RE: Adequacy Review No. 2 - Response TR-08; M-1992-009

EXHIBIT D - Gillette Mine

Technical Revision to Exhibit D of the Mining Plan

Exhibit D Showing Sediment Pond Area

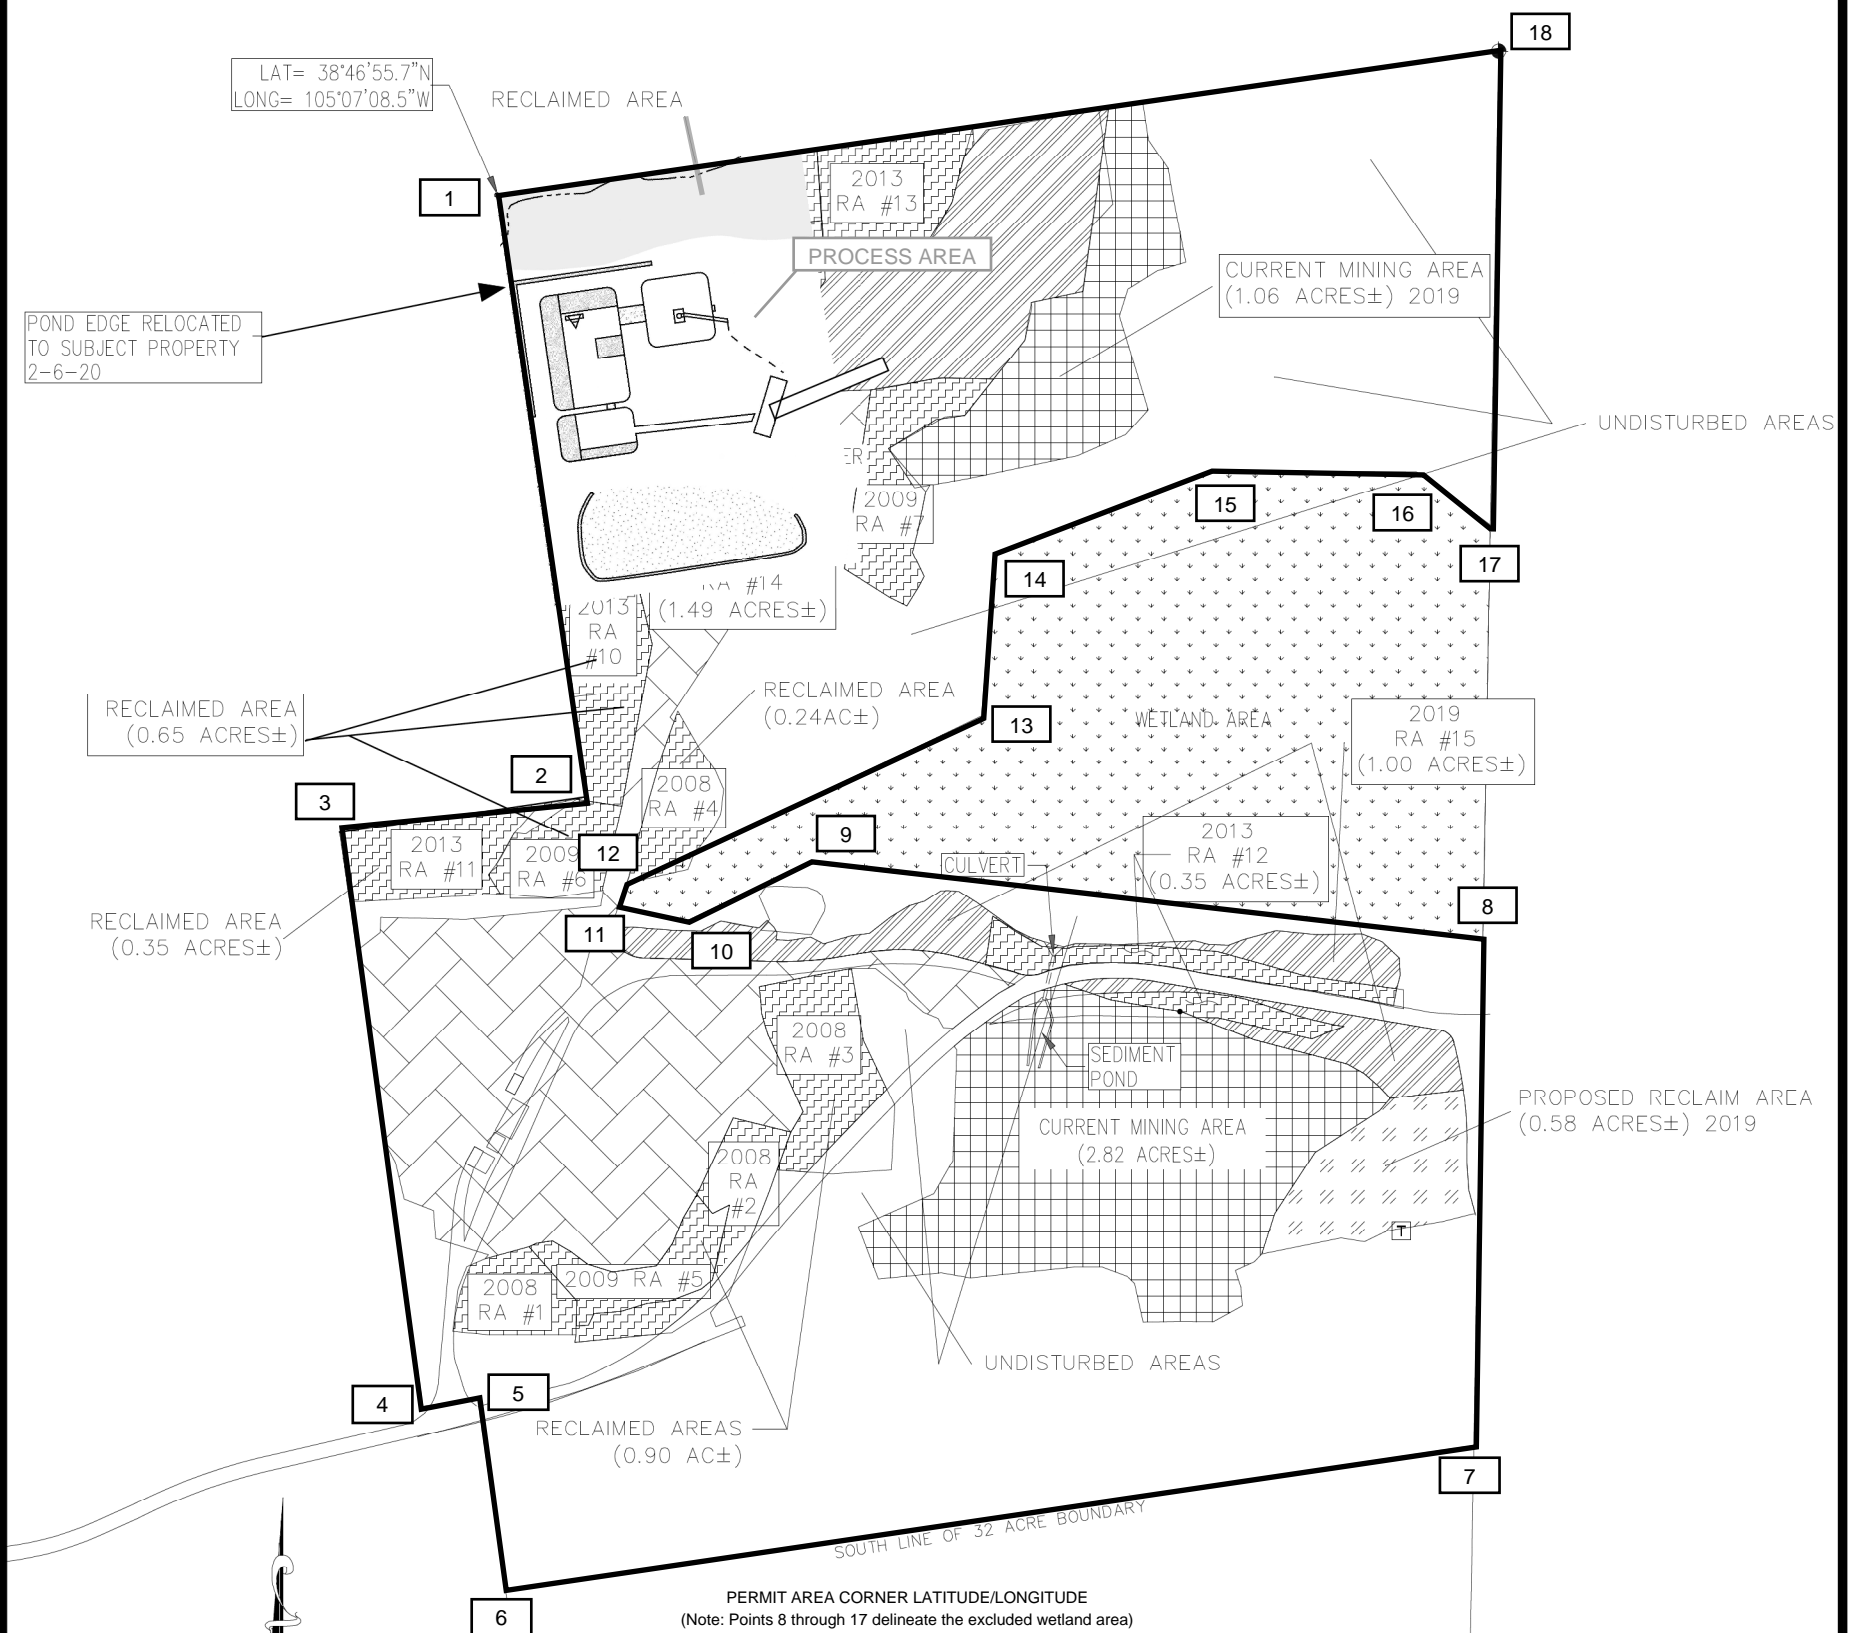
9. *Comment:* The latitude/longitude coordinate for Boundary Corner 1 (the northwest corner) appears to plot a point approximately 50 feet west of the intended location. Please confirm this is the correct coordinate or provide a revised Exhibit D Map and latitude/longitude coordinates table reflecting a revised coordinate for Boundary Corner 1.

10. *Comment:* In response to Adequacy Item #8, the Operator submitted a revised Exhibit D Map identifying the latitude/longitude coordinates for the 8 permit boundary corners. After plotting these, the Division determined these account for approximately 38.51 acres. The Division has discovered in 2009, in response to a request by the Division, the Operator submitted a map clarifying the 32-acre permit boundary. The 6.51-acre wetlands area is not included within the permit boundary. Please revised the new Exhibit D Map and the latitude/longitude coordinates table to include the 10 additional corners around the wetlands area. Please also revise the Exhibit D Map to clearly depict the 32-acre permit boundary. The Division suggests using a heavy weighted line to portray the permit boundary.

Response: A transcription error on the reported location of the point was found and corrected. The originally posted data provided in the May 18 response letter showed a longitude of 105.1192°. The correct longitude for this corner is 105.11902°. We have revised the northwest corner point (no. 1) latitude to -105.1190°. This revision results in moving the corner approximately 50 feet to the east. This change has been reflected in the Exhibit D table.

Response: The additional corner points around the wetlands area have been included on the map and the coordinates of these points have been added to the table on the Exhibit D map. As requested, the permit boundary line weight (including the wetland area delineation) has been increased on the Exhibit D map.
